## Service Bulletin No. 051

### **Replacement of P/N 69C13 Base in 65C30 Series Sealed Control Assembly**

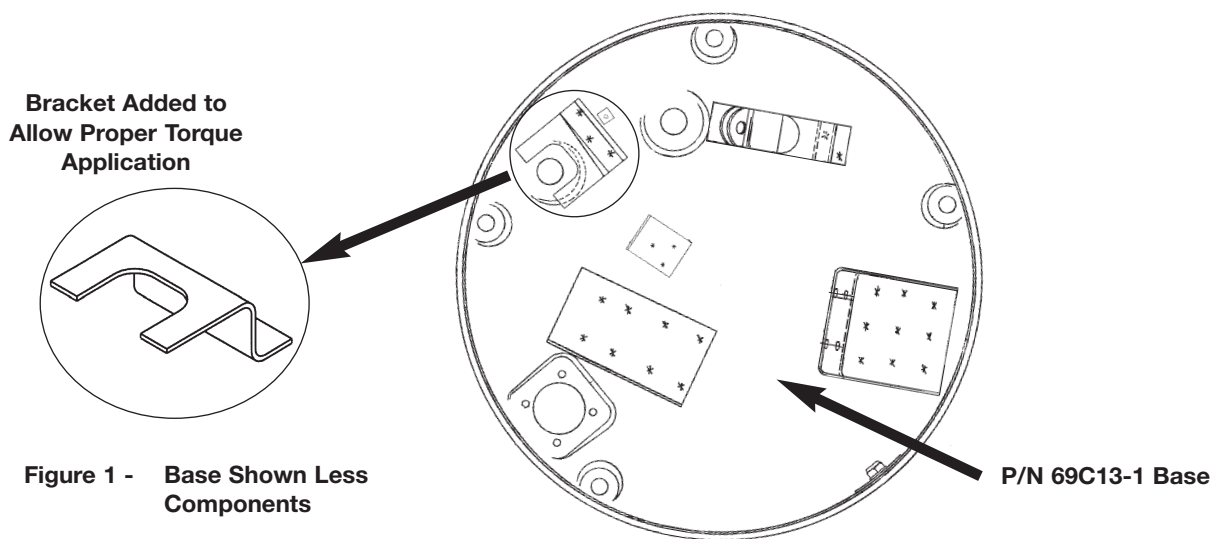
- (1) Install new P/N 69C13-1 base as shown in Figure 1.
- (2) Using the assembly instructions found in the P/N 95C35 manual, build the assembly on the new P/N 69C13-1 base. In general, assembly is done in reverse of disassembly per the 93C95 manual with two exceptions.

- (a) When installing the fuel inlet fitting (union is on fuel filter #75) through the new base, install the existing washer (#69) and a new copper gasket (#68), P/N MS35769-8 on the fitting, then place the two flats of the fuel filter in the bracket as shown in Figure 1.
